COLORADO DIVISION OF RECLAMATION, MINING AND SAFETY
MINERALS PROGRAM INSPECTION REPORT
PHONE: (303) 866-3567

MINE NAME: Cresson Project	MINE/PROSPECTING ID#: M-1980-244	MINERAL: Gold	COUNTY: Teller
INSPECTION TYPE: Monitoring	INSPECTOR(S): Timothy A. Cazier	INSP. DATE: September 16, 2015	INSP. TIME: 07:15
OPERATOR: Cripple Creek & Victor Gold Mining Company	OPERATOR REPRESENTATIVE: Chris Hanks & Meg Burt	TYPE OF OPERATION: 112d-3 - Designated Mining Operation	
REASON FOR INSPECTION: Normal I&E Program	BOND CALCULATION TYPE: None	BOND AMOUNT: \$173,434,420.00	
DATE OF COMPLAINT: NA	POST INSP. CONTACTS: None	JOINT INSP. AGENCY: None	
WEATHER: Clear	INSPECTOR'S SIGNATURE: 	SIGNATURE DATE: November 17, 2015

Photo 3. Currently undisturbed proposed substation location (looking SW towards Shelf Road).

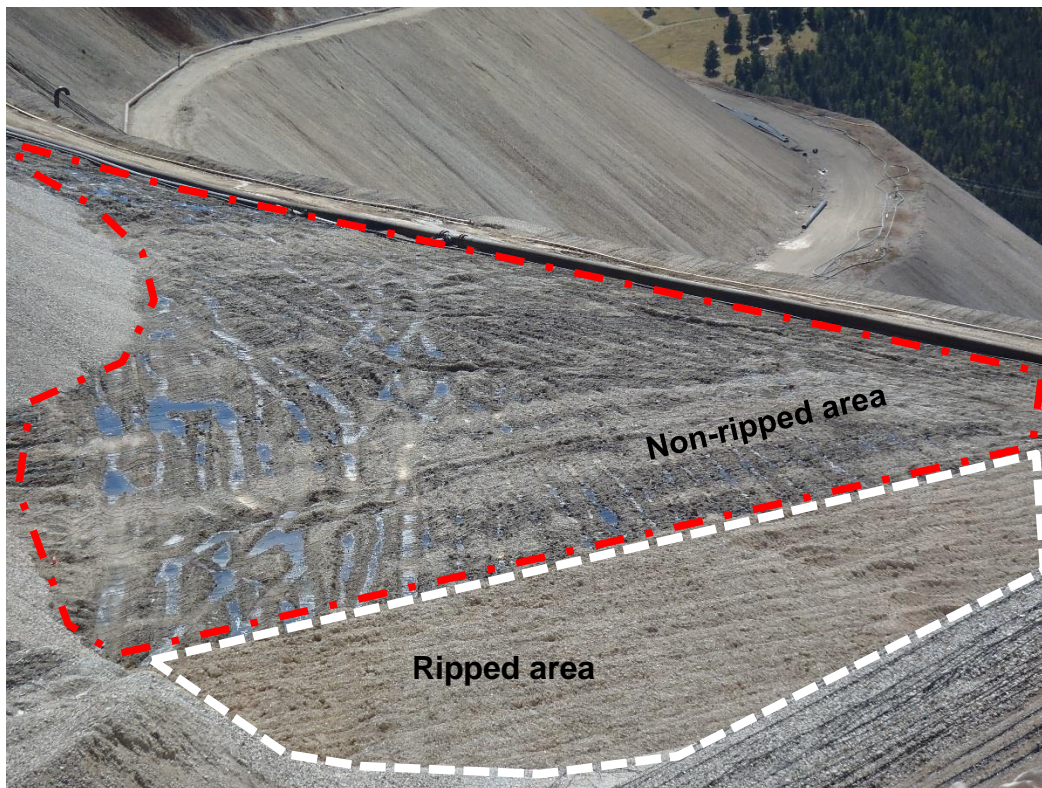
Mr. Hanks pointed out the mine is beginning to excavate the area for the proposed sump at the toe of the SGVLF toe berm (see **Photo 2**). The liner was expected to be installed prior to the next inspection. The proposed substation location was visited. It is at the bottom of Squaw Gulch where it intersects Shelf Road. It was undisturbed at the time of the inspection (see **Photo 3**).
